BILL NO. 2279

ORDINANCE NO. 2113
See Ord 2112; T-2-00 Sky Ridge Subdivision

Z-7-00 - Barker Homes Inc.

A GENERAL ORDINANCE REZONING REAL PROPERTY OWNED BY BARKER HOMES INC. FROM PD (PLANNED DEVELOPMENT - CANYON HILLS) TO PD (PLANNED DEVELOPMENT - SKY RIDGE) ON APPROX. 10.73 ACRES LOCATED AT THE EASTERN TERMINUS OF DISC DRIVE AND WESTERN TERMINUS OF CANTINA DRIVE AND THE EASTERN TERMINUS OF CLOUD PEAK DRIVE; AND PROVIDING OTHER MATTERS PROPERLY RELATING THERETO.

FIGURE 1—OVERALL AREA

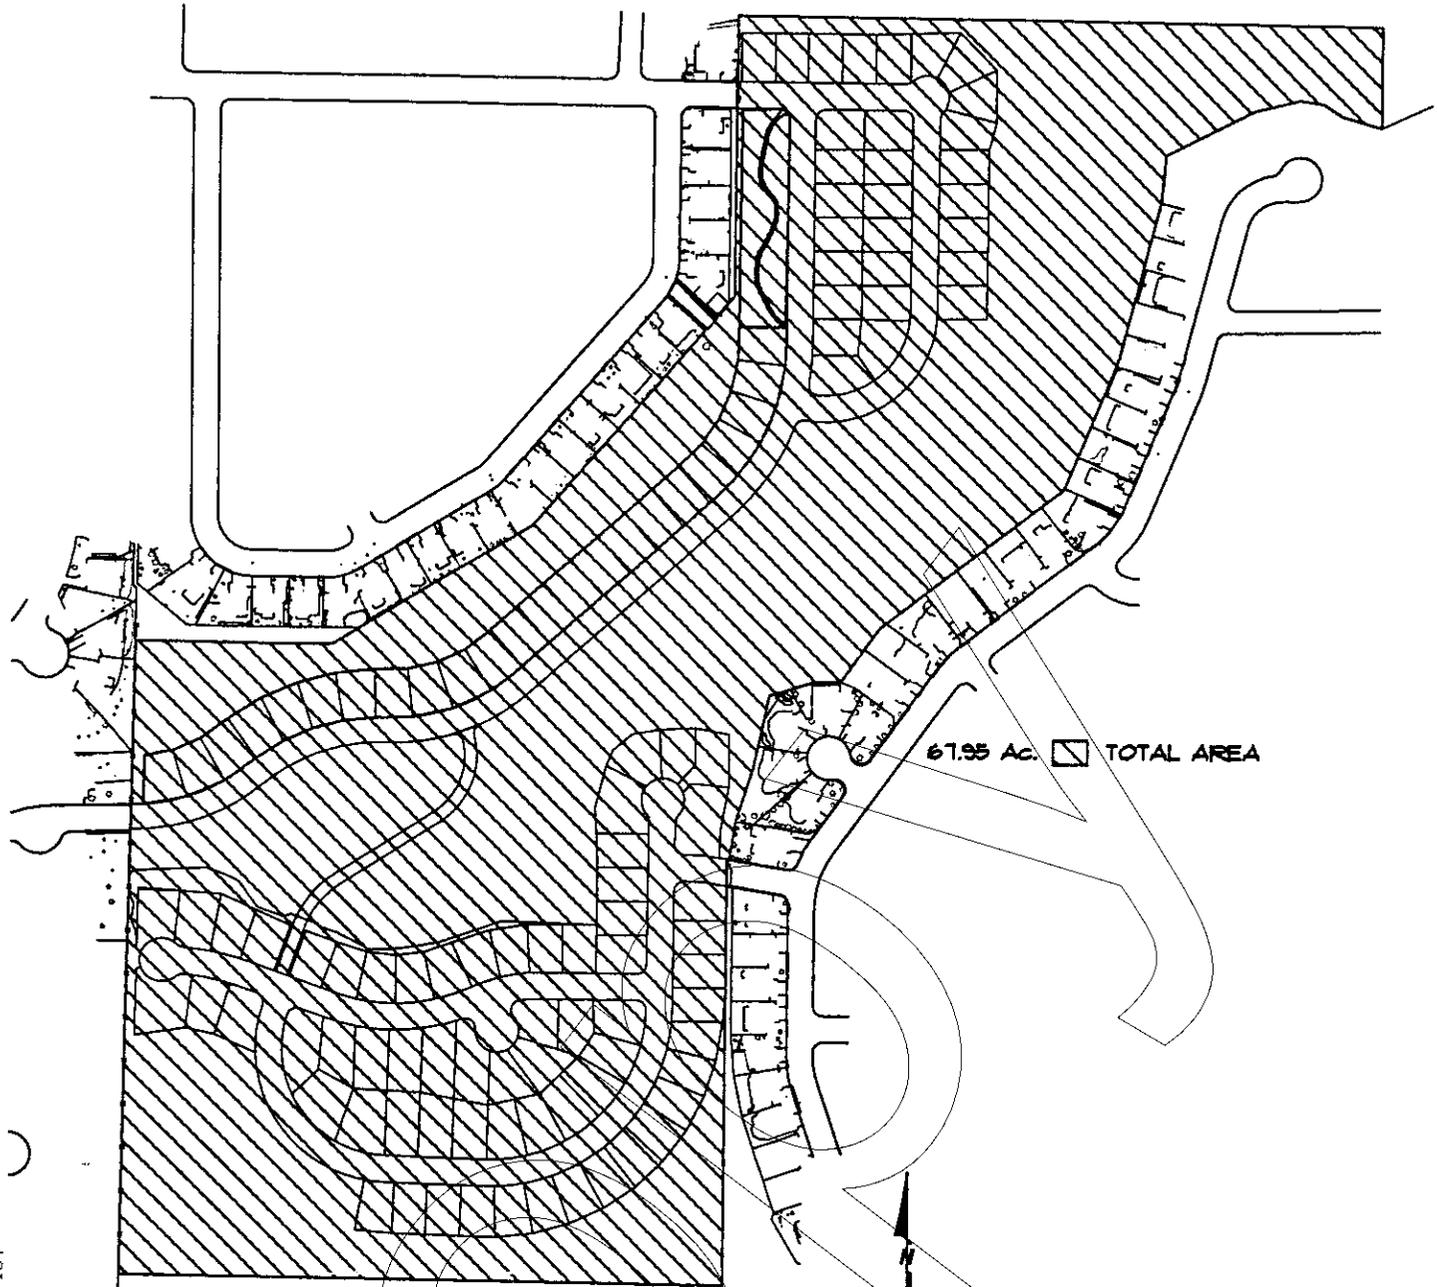
Amend the Figure 1 graphic:

**SKY RIDGE SUBDIVISION
GRADING PLAN - CUT/FILL EXHIBIT
ANNEXATION & PD SUBDIVISION
SHEET 2 OF 3**

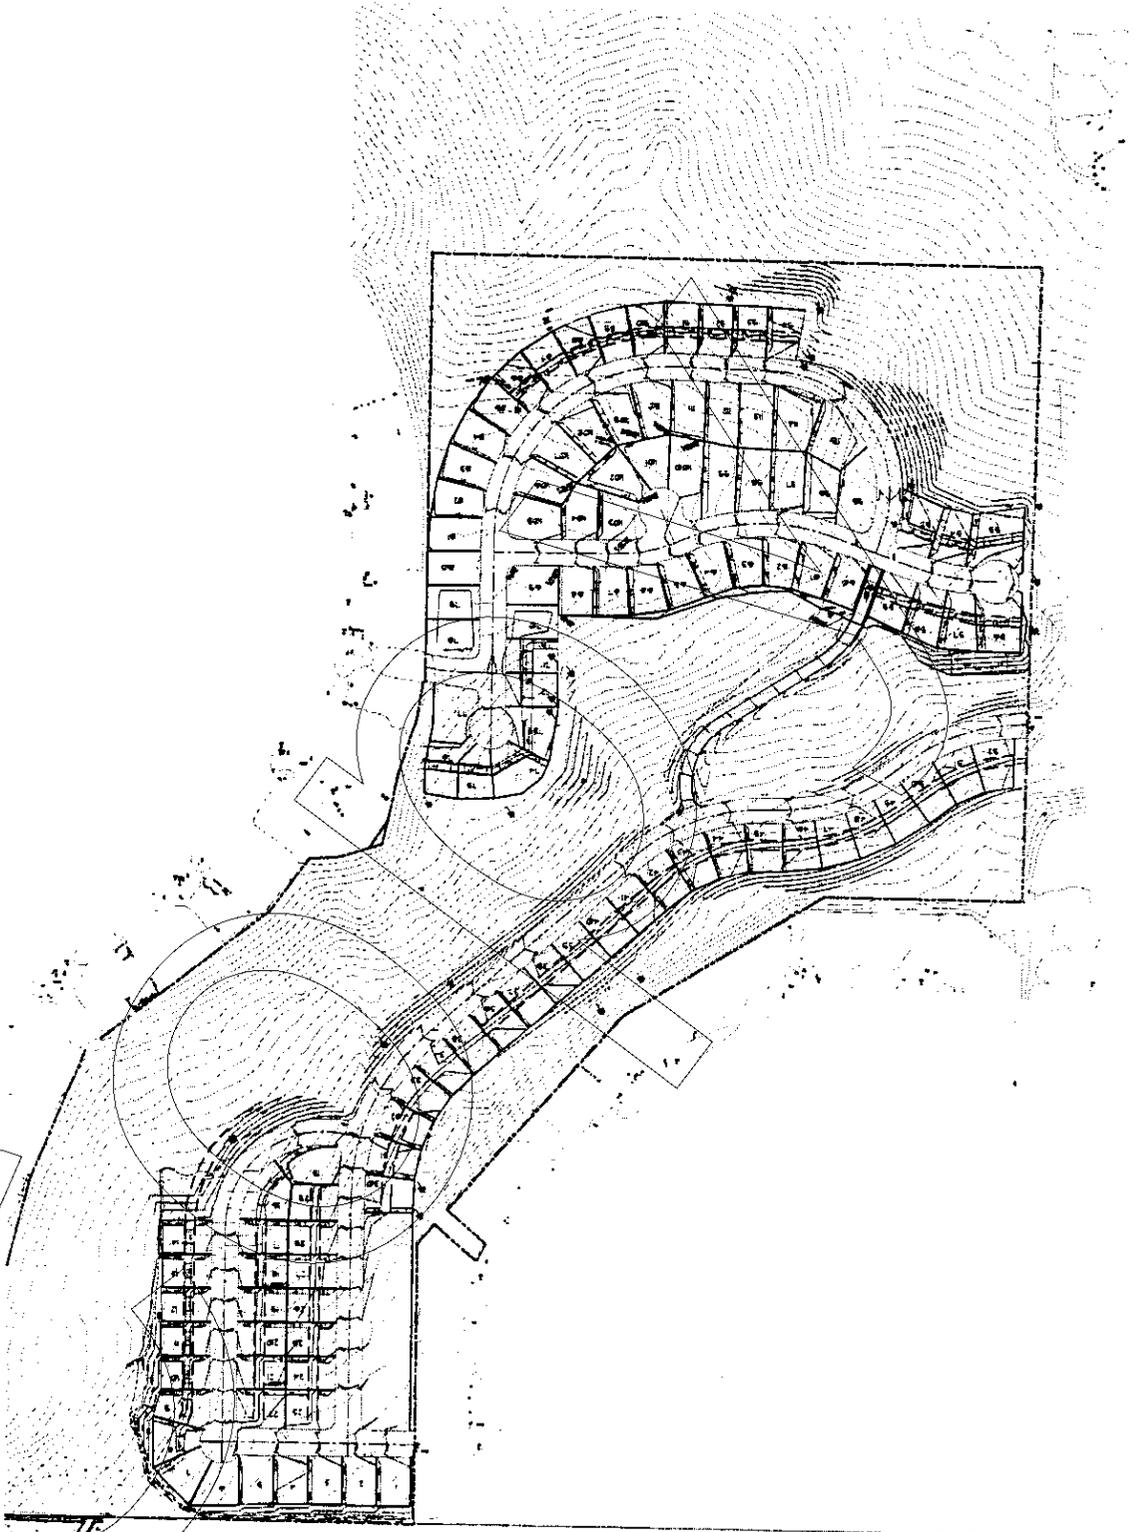
Sky Ridge Subdivision Grading Plan - Cut/Fill Exhibit Sheet 2 of 3:

- Reduced Sheet 2 of 3 is illegible.
- 08/10/01 Full sized Sheet 2 of 3 has the following discrepancies:
 - There is no Sheet 2 of 3; there is a Sheet 1 of 2 and Sheet 2 of 2 - Grading plan South and North. Same discrepancies as 08/17/01 Sheets 2a and 2b, except included north arrow.

- 08/17/01 Full sized Sheet 2a and 2b of 3 has the following discrepancies:
 - Does not include a scale;
 - Does not include a contour interval;
 - Does not include a legend defining what the map symbols are (ex., heavier lines on property lines on Sheet 2b, but not included on Sheet 2a);
 - Difficult to read top-of-wall and bottom-of-wall elevations or partial elevations (only tops)
 - Map indicates some 2:1 slopes remaining within private properties in violation of the Handbook language;
 - Missing slope gradient on cut and fill slopes;
 - Rockery walls exceeding 8 feet in height(extreme examples include a 15- and 31-foot high rockery wall); and
 - Indicates the continuation of the 3:1 bench through to the vacant cut slope south of the northern portion of the project's lots.

**SKY RIDGE SUBDIVISION
UTILITY PLAN
ANNEXATION & PD SUBDIVISION
SHEET 3 OF 3**

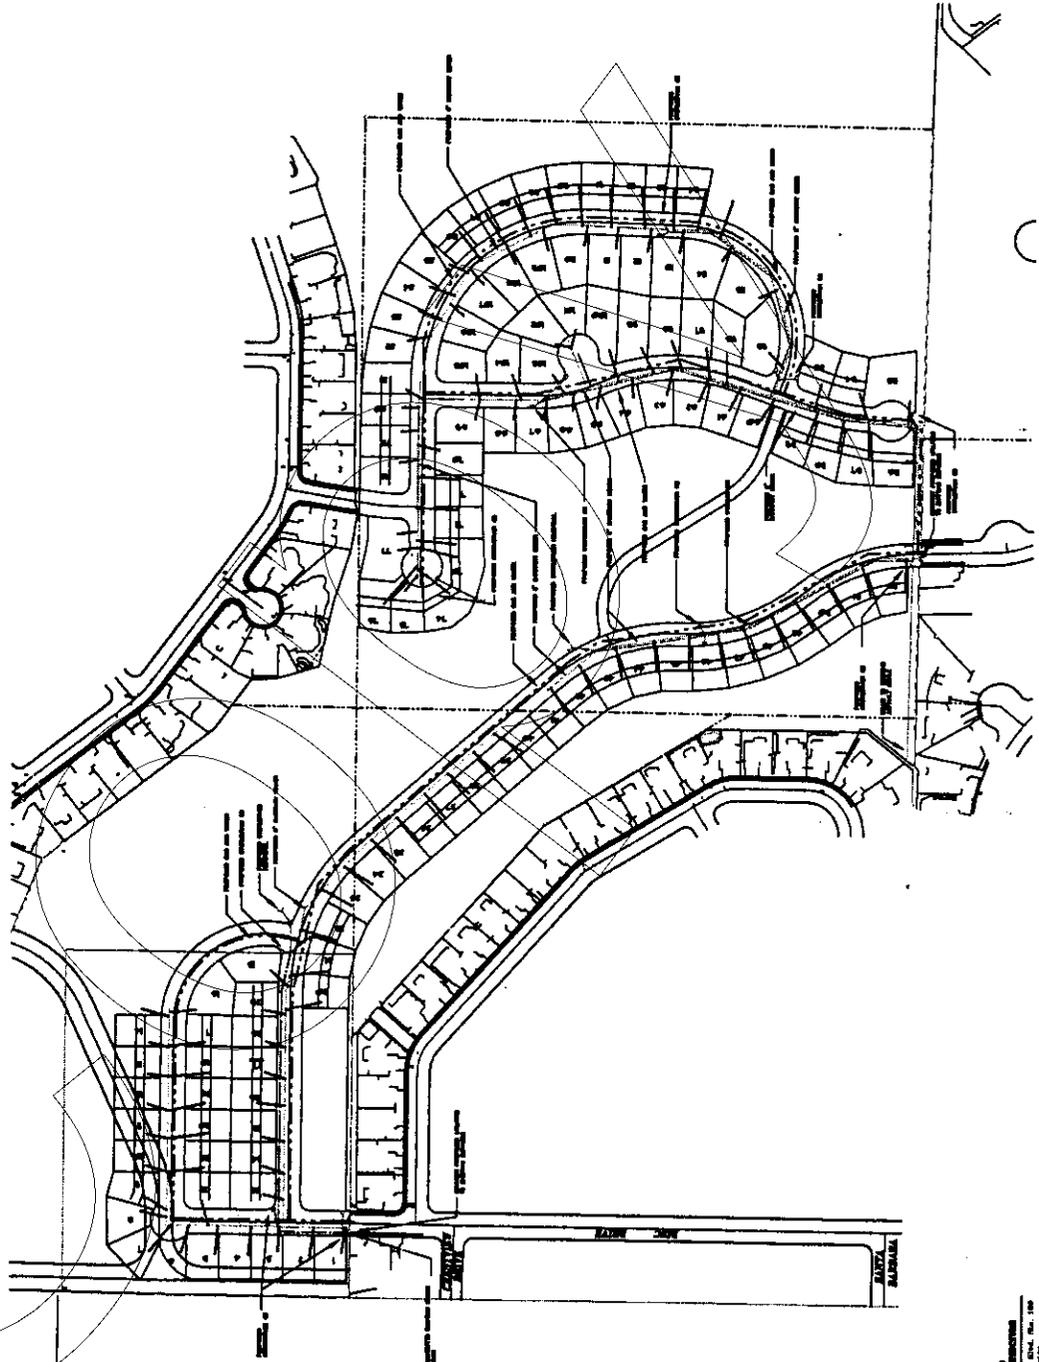
Sky Ridge Subdivision Utility Plan Sheet 3 of 3:

- Reduced Sheet 3 of 3 is illegible.
- 08/10/01 Full sized Sheet 3 of 3 has the following discrepancies:
 - Does not include a north arrow and scale.
- 08/17/01 Full sized Sheet 3 of 3 has the following discrepancies:
 - Does not include a north arrow and scale.
